Appendix 1  
Anvil Hill Coal Project  
Independent Hearing and Assessment Panel  
*Noise and Blasting*

I have been appointed to the aforementioned Panel and in particular in respect of noise and blasting issues.

INP Wind Rose Analysis

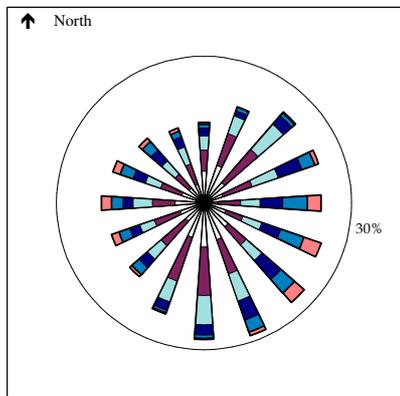
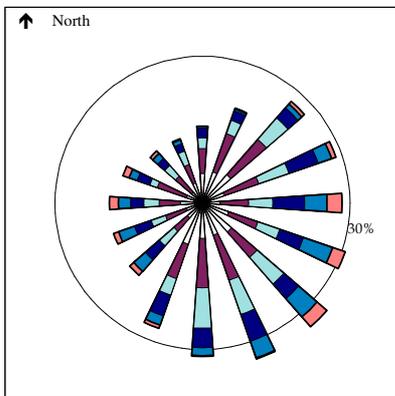
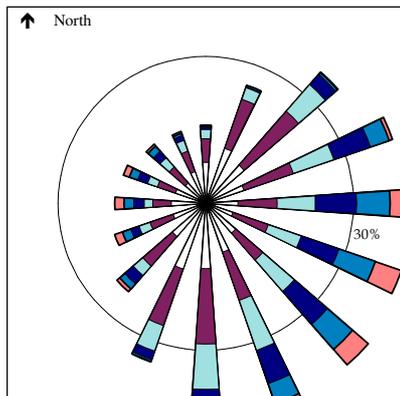
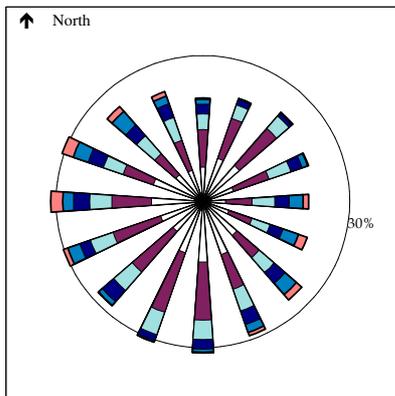
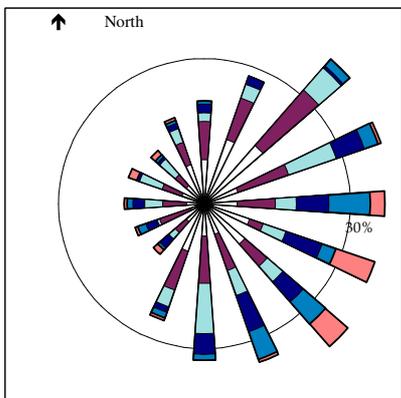
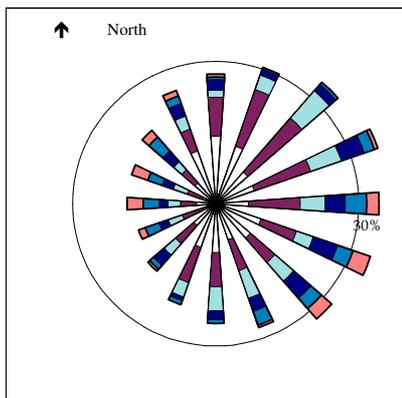
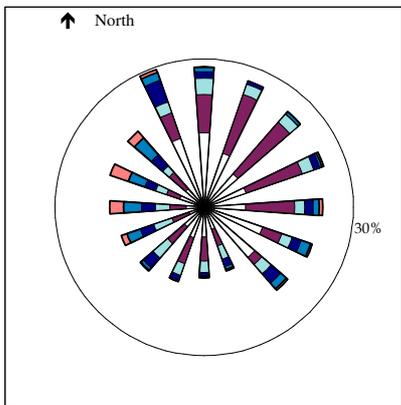
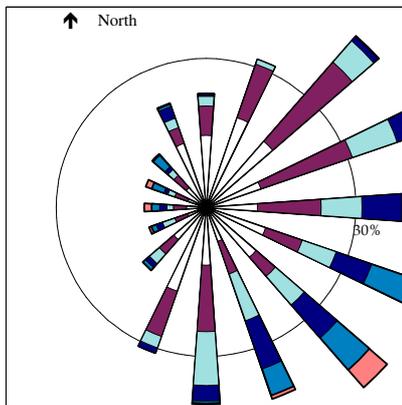
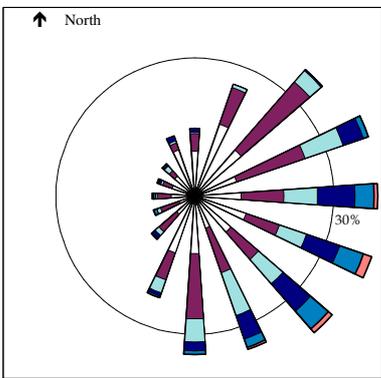
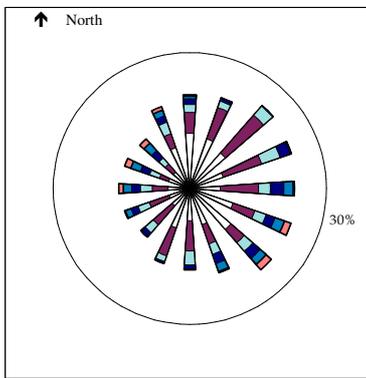
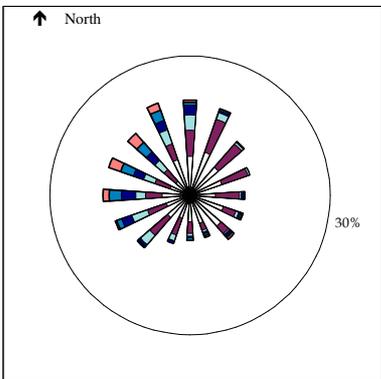
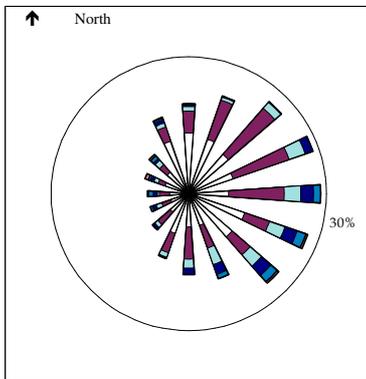
A thorough analysis of the vector components of the 10-minute wind data described above was undertaken. The assessable wind direction is graphically demonstrated in *Annex A* for the 16 standard directions. Where the windrose arm exceeds the 30 % threshold, as indicated by the rose, this direction is considered assessable. The assessable wind speed was also determined in accordance with the intent of the INP and is the upper tenth percentile speed (below 3m/s) for each of the assessable directions. The wind directions and wind speed determined to be a feature of the area in accordance with the INP are summarised in *Table 3*.

The highlighted values are those that constitute the highest wind speed for that (standard) direction and therefore the minimum set of conditions that should be modelled for assessment purposes according to the INP. Where day and night operations are the same, only the higher wind speed of those highlighted for a given direction need to be modelled.

The implication for this proposal is most significant for receivers to the north west and west of the site, given the relatively higher wind speeds from the south east and east. This finding is also consistent with Panel member Mr Robin Ormerod's analysis.

The **recommendation** therefore is to remodel using the INP winds derived earlier in Table 3 (eg 2.5m/s from the south east and east) to define potential noise impact for receivers to the north west and west of the site. Alternatively, rely on thorough noise monitoring to determine the extent of impacted properties.
